## PARTS/SERVICE BULLETIN

No: 4-20

### Subject: New Scraper Arm Kit

#### #27491 – Scraper Arm Kit

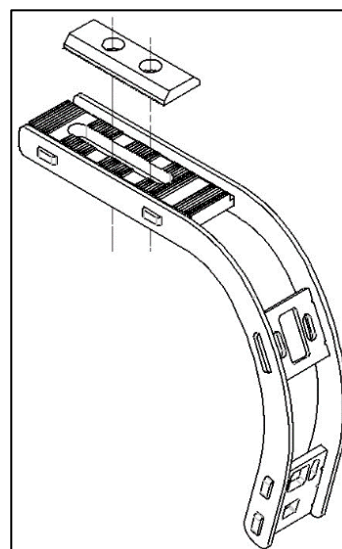
We have redesigned the scraper arm to increase its strength & durability for V4 tines.

This is primarily due to the larger surface area of the new rounded scraper design to fit the rounded Press Wheel offering.

- The new scraper arm kits are a direct replacement for the previous scraper arm kit except they no longer require the mount plate.
- Apply 68 Nm of torque to tighten the nuts on the 8.8 cup head bolts.

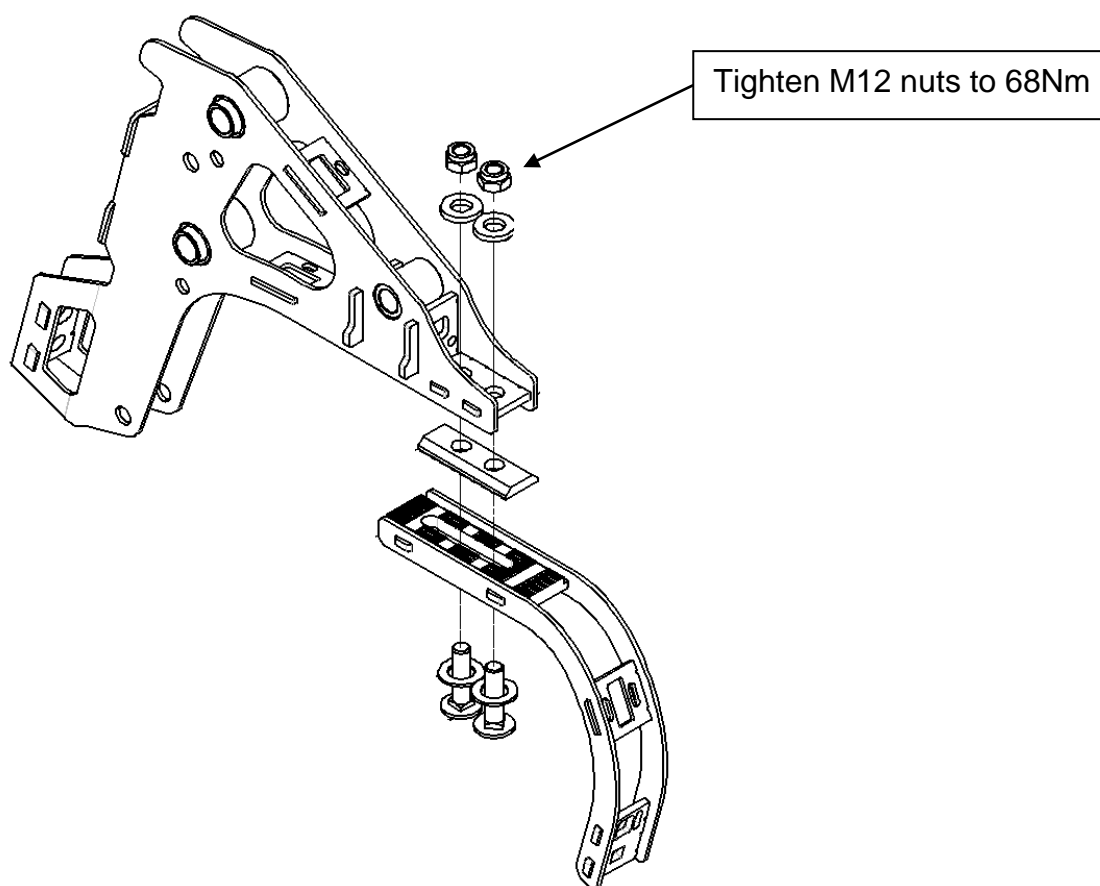
Old type with Mount Plate

Current type
